February 24, 2021

Addendum 2

Morehead City Country Club
Clubhouse
Morehead City, NC

The following addendum shall supersede previous information and does hereby become part of the contract documents.

BD-6.1

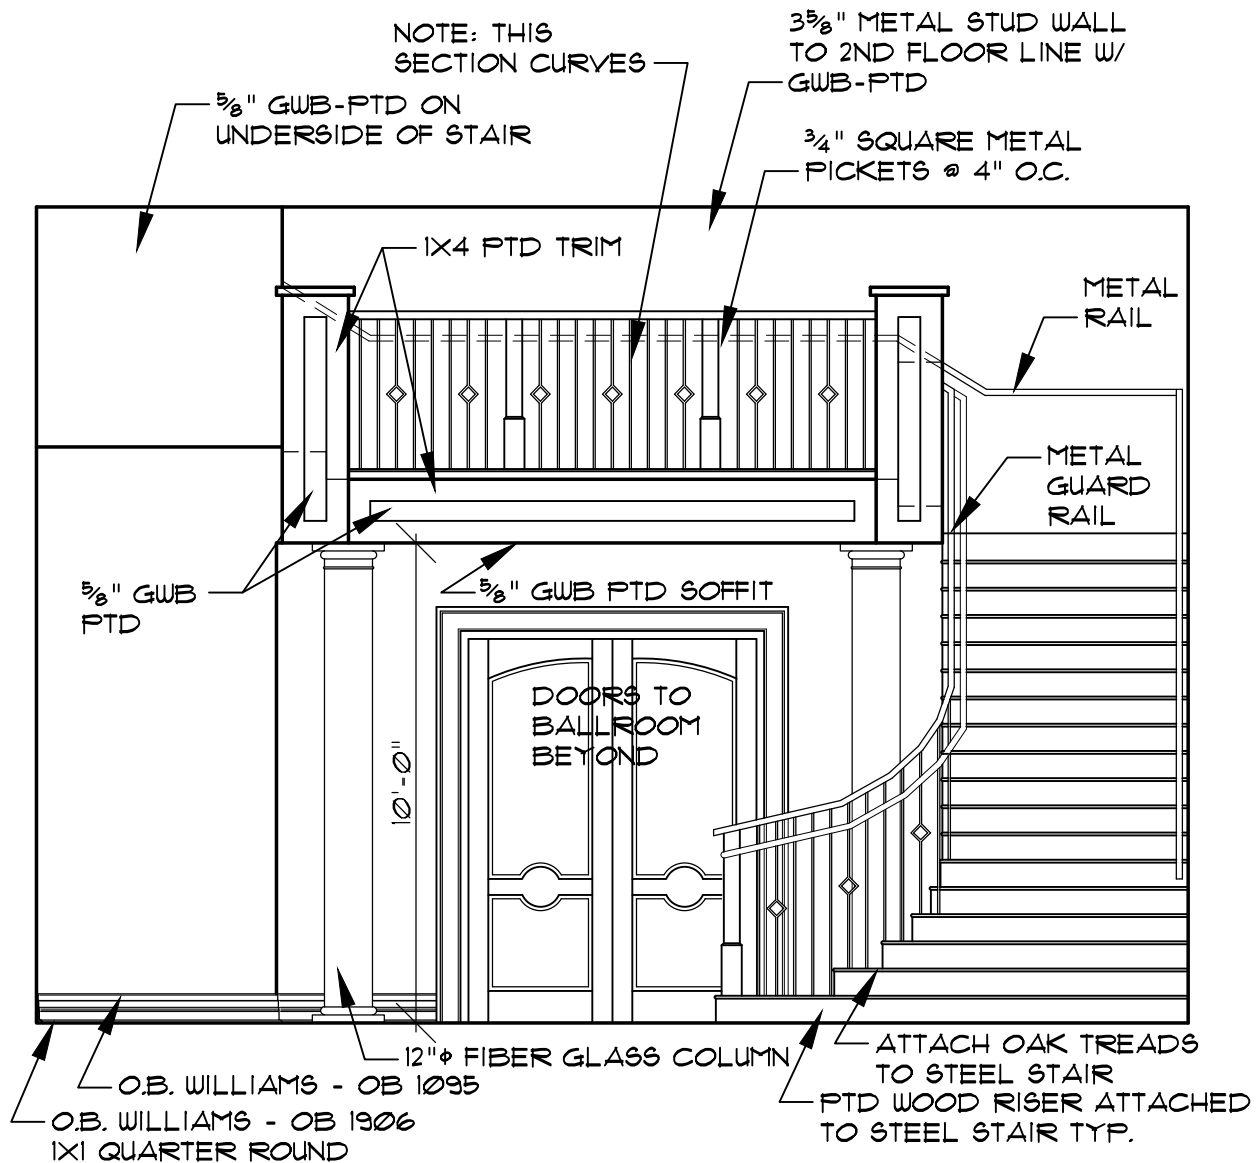
- See attached BD-6, BD-6.1, BD-6.2, BD-6.3, and BD-6.4 for interior stair concept. Final details will be reviewed with Shop Drawings from Steel Stair Manufacturer.
- See attached SK1.0 and SK1.1 for revisions to structure to accommodate interior stair support.
- See attached BD-9 and BD-9.1 for sliding pocket wall added in Member Dining 204.
Please note in BD-9.1 relocated lights and HVAC registers/returns. Please accommodate with revised/extended duct work as required.

VIEW "C"

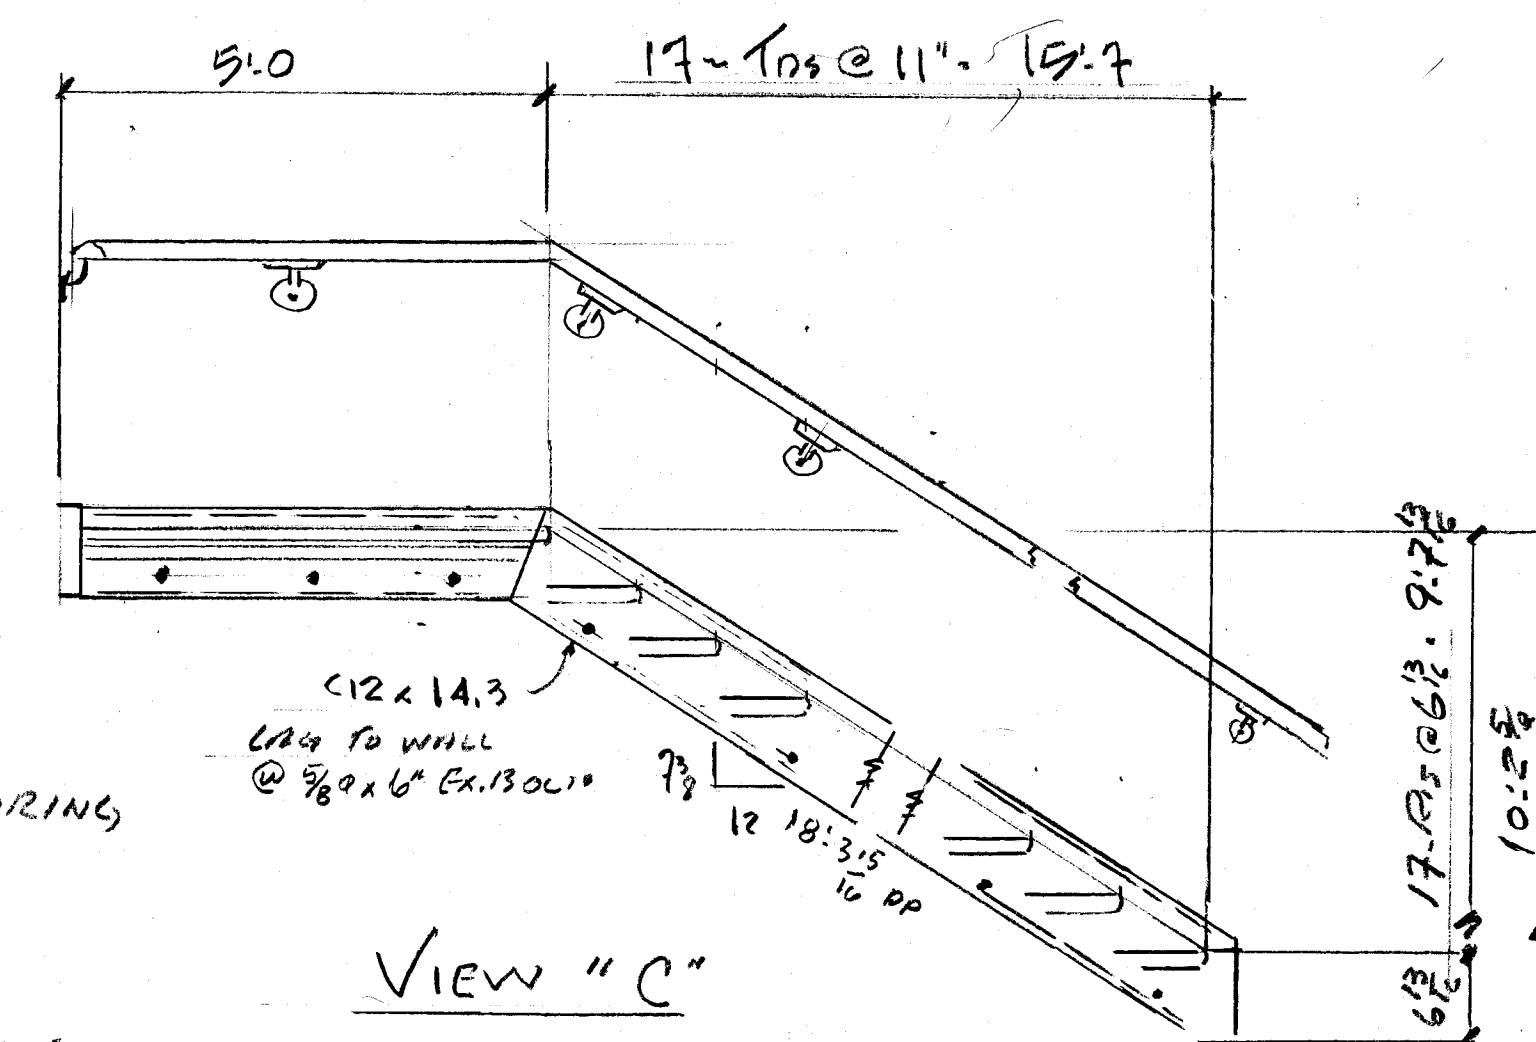
THIS WILL NEED SOME SUPPORT

MEMBER DINING
POCKET WALL RCP

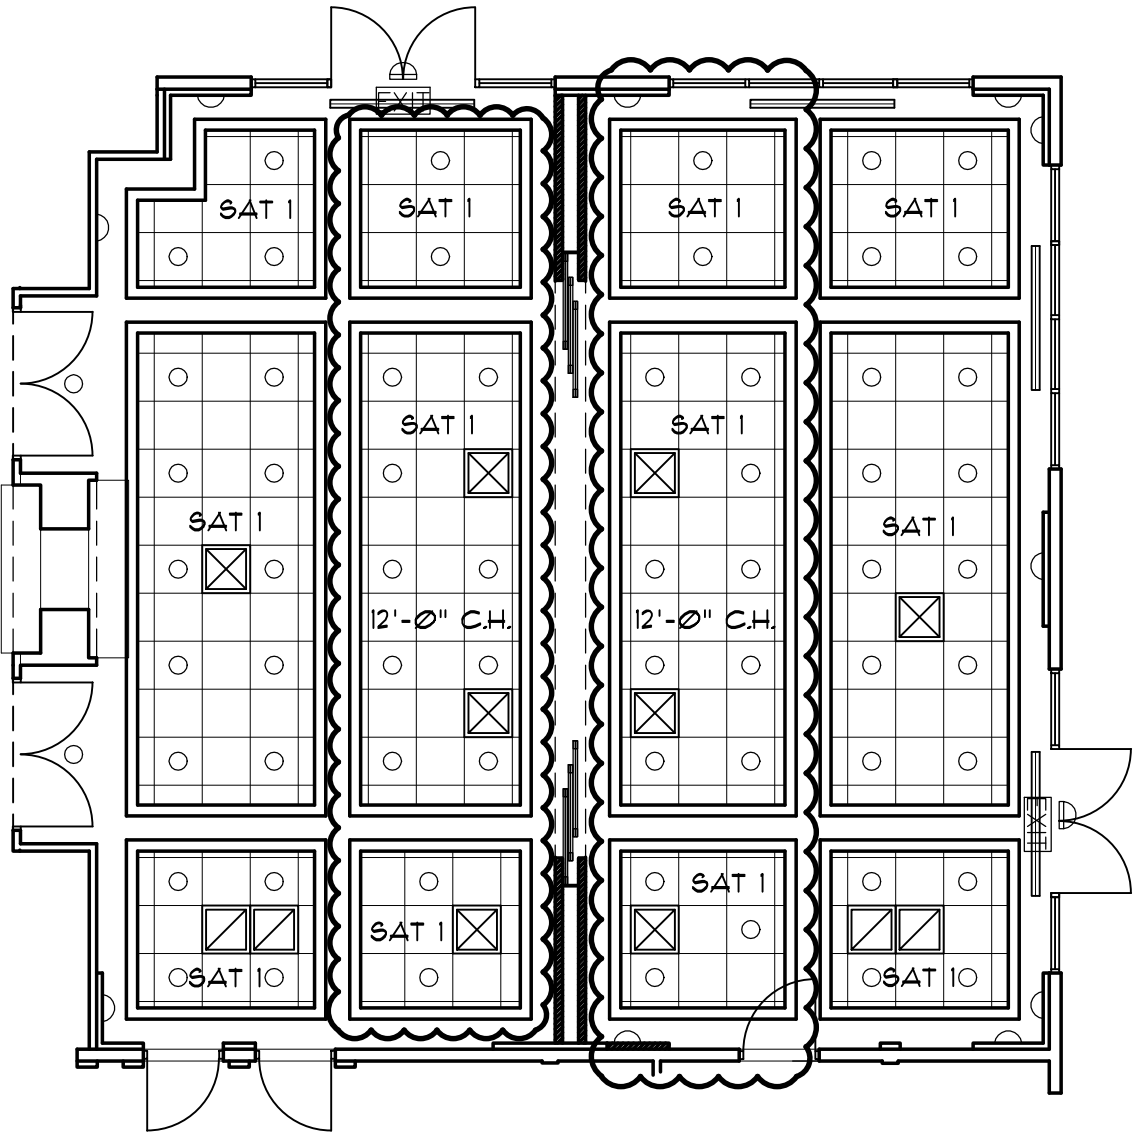
NOTE: HVAC REGISTERS AND LIGHTS
RELOCATED TO ACCOMMODATE NEW
POCKET DOOR WALL
